| SUNDRY NOTICES AND REPORTS ON WELLS (DO NOT USE THIS FORM FOR PROPOSALS TO DRILL OR TO DEEPEN OR PLUG BACK TO A DIFFERENT RESERVOIR. USE "APPLICATION FOR PERMIT" (FORM C-101) FOR SUCH PROPOSALS.) 1. Type of Well: Oil Well <input checked="" type="checkbox"/> Gas Well <input type="checkbox"/> Other <input type="checkbox"/> | | WELL API NO. 30-005-10474 |

Cano Petro Of New Mexico
Cato San Andres #098
API: 30-005-10474
Chaves County, New Mexico

Plug And Abandonment Procedure

Cato San Andres #098

Proposed Wellbore Diagram

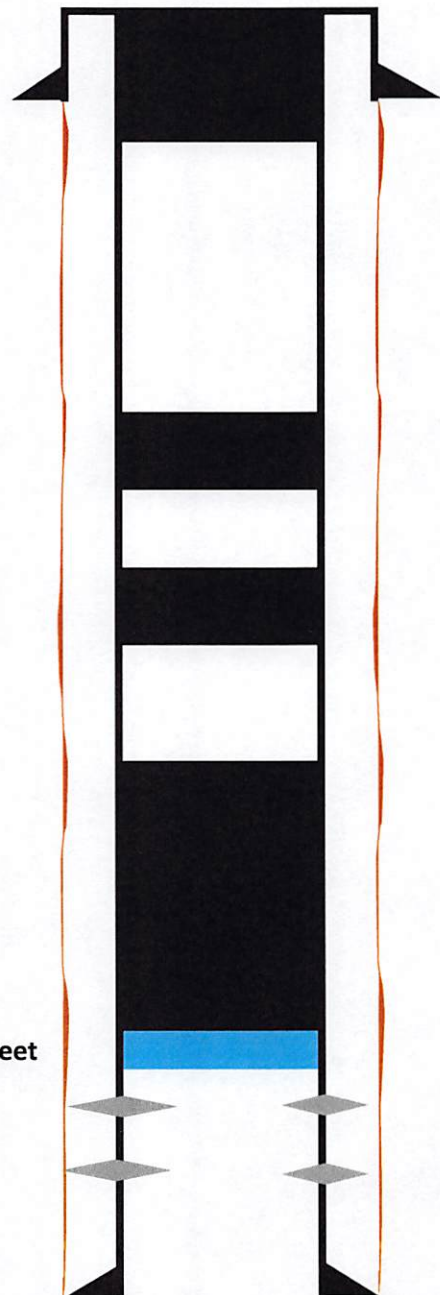
Perf & Sqz all
 plugs where no
 cmt behind pipe.

Perf & Sqz all csg
 shoes.

Adhere to NMOCD
 COAs attached.

| Created By | Condition | Condition Date |
|---------------|---|----------------|
| john.harrison | Approved w/conditions. Adhere to NMOCD COAs attached. | 6/1/2023 |
